# RENESAS TECHNICAL UPDATE

Product Category	MPU/MCU		Document No.	TN-SH7-A788A/E	Rev.	1.00
Title	Corrections to the Usage Notes and Hardware Manual concerning output waveform control during synchronous counter clear operations in the MTU2 and MTU2S complementary PWM mode.		Information Category	Technical Notification		
Applicable Product	See below	Lot No.	Reference Document	See below		
		All

Figure 1 Condition (1) Synchronous Clearing Example

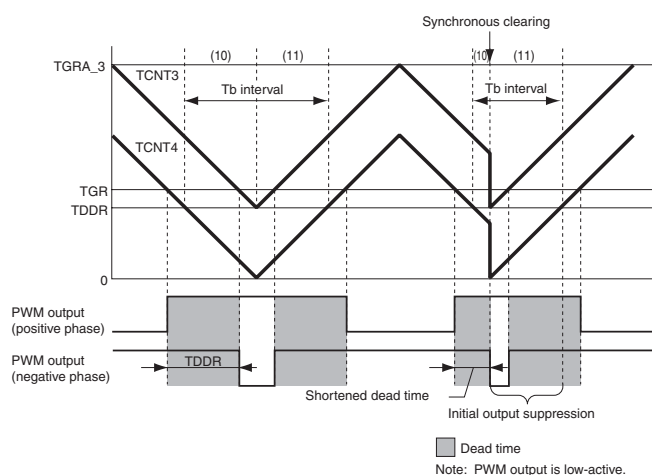
In complementary PWM mode, when output waveform control during synchronous counter clearing is enabled (WRE in the TWCR register set to 1), the following problems may occur when condition (1) or condition (2), below, is satisfied.

- Dead time for the PWM output pins may be too short (or nonexistent).
- Active-level output from the PWM negative-phase pins may occur outside the correct active-level output interval

Condition (1): When synchronous clearing occurs in the PWM output dead time interval within initial output suppression interval (10) (figure 1).

When using synchronous clearing, make sure to set compare registers TGRB\_3, TGRA\_4, and TGRB\_4 to a value twice or more the setting of dead time data register TDDR.

Figure 2 Condition (2) Synchronous Clearing Example

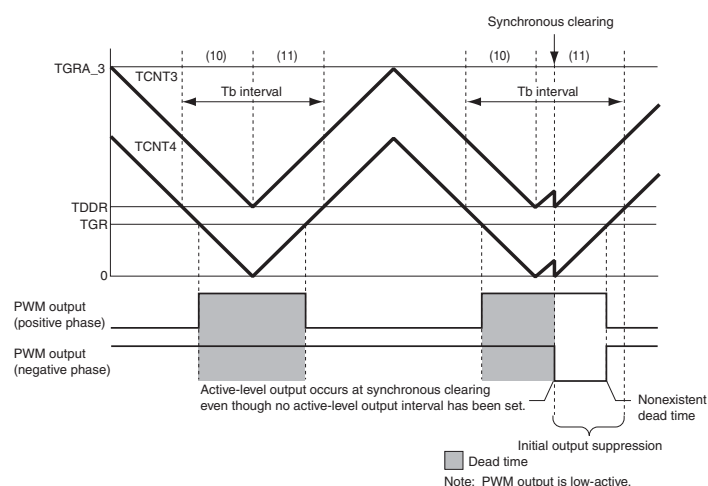
Condition (2): When synchronous clearing occurs within initial output suppression interval (10) or (11) and  $TGRB\_3 \leq TDDR$ ,  $TGRA\_4 \leq TDDR$ , or  $TGRB\_4 \leq TDDR$  is true (figure 2).
